Re: Comments on Report for HDD PA-CH-0421.0000-RD & PA-CH-0421.0000-RD-16

Comments on HDD PA-CH-0421.0000-RD & PA-CH-0421.0000-RD-16

Attachment A

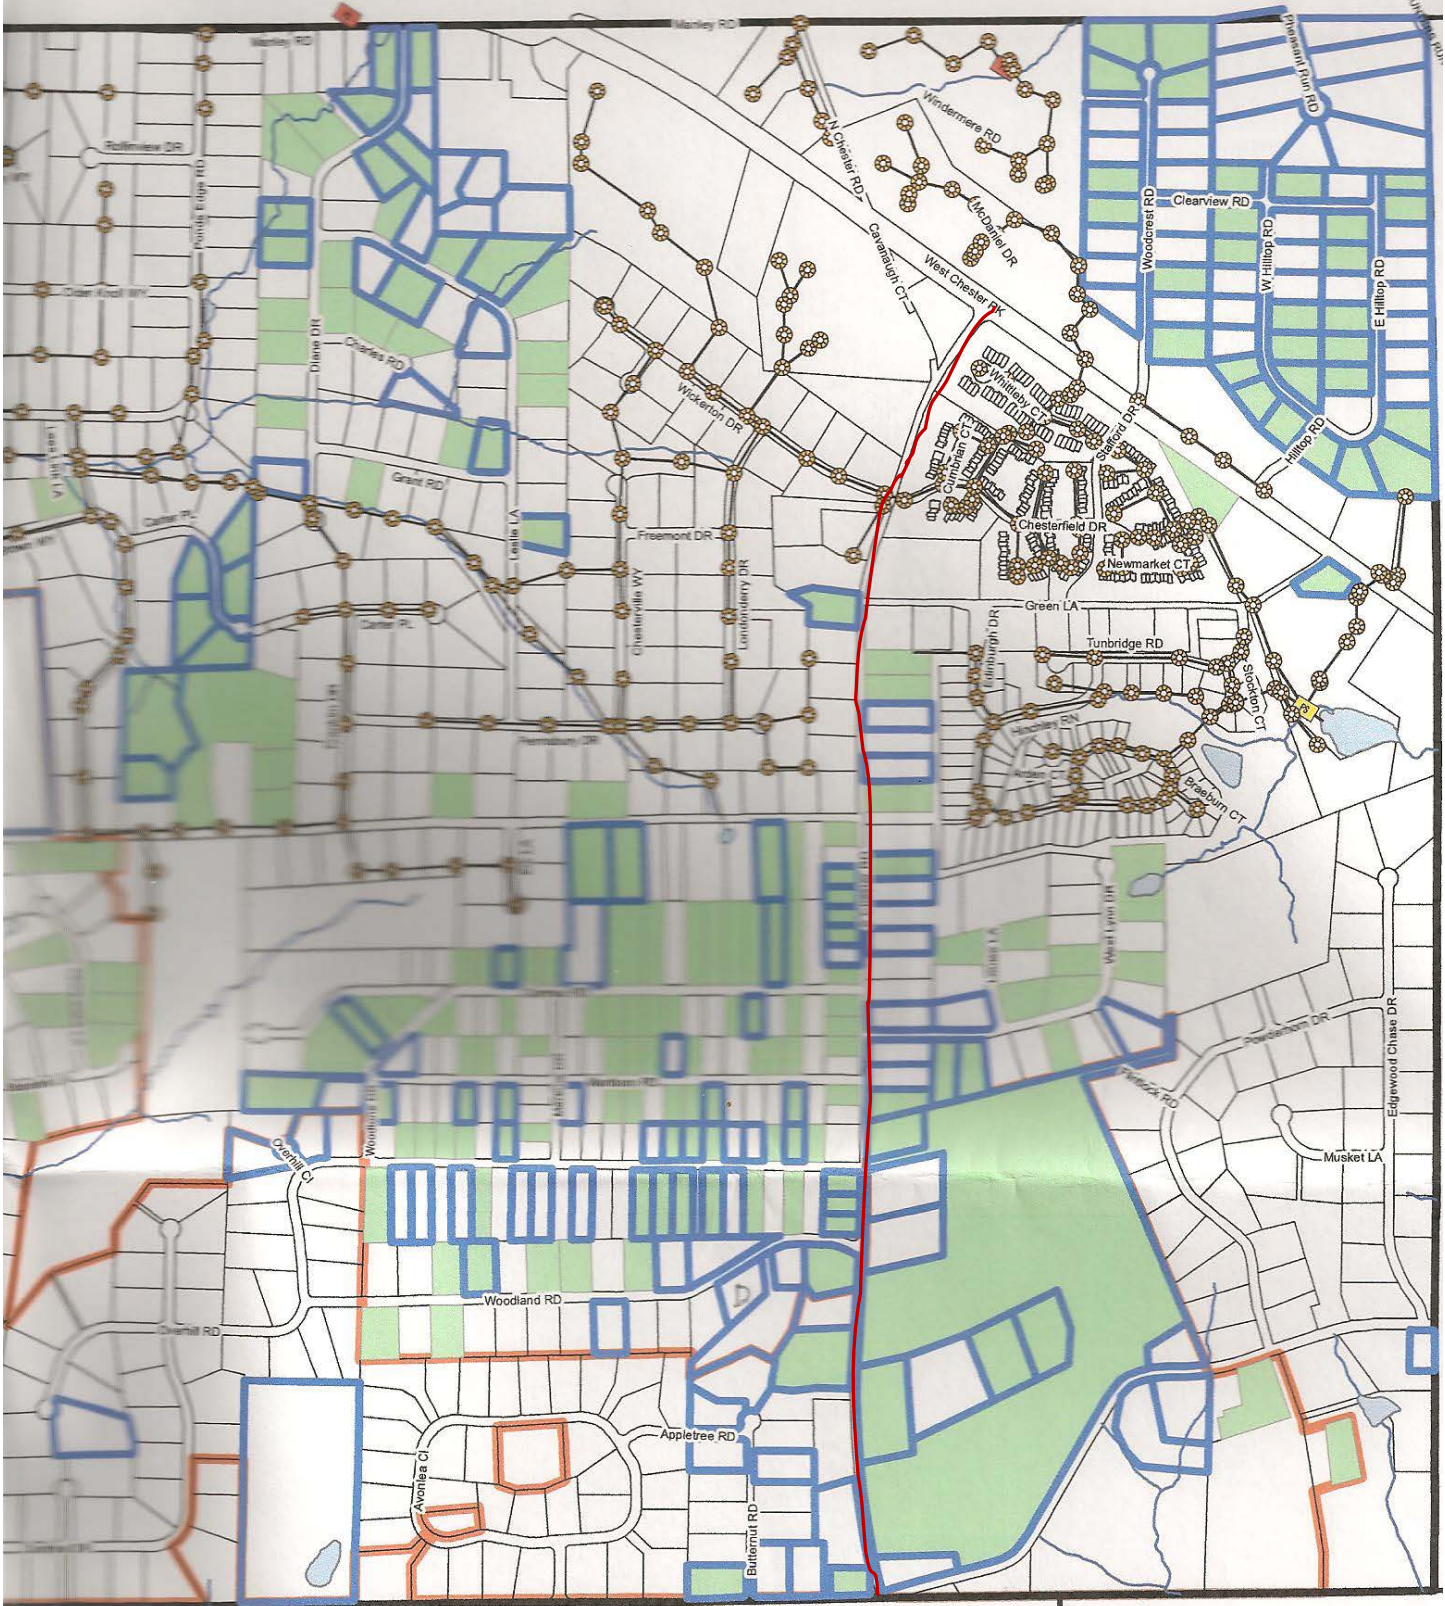
8. This drilling in my neighborhood would cut through the aquifer that feeds my well and the wells of others where I live. I have attached a map as Attachment A to this declaration that shows which properties in my area get their water from wells. My property is marked with a "D" toward the bottom of the map. The road which Sunoco would drill under has a red line through it, to the right of my property. As you can see, many of the properties along the pipeline route use well water.

I put a red line on South Chester Road (Route 352). Mike put a "D" on our property.
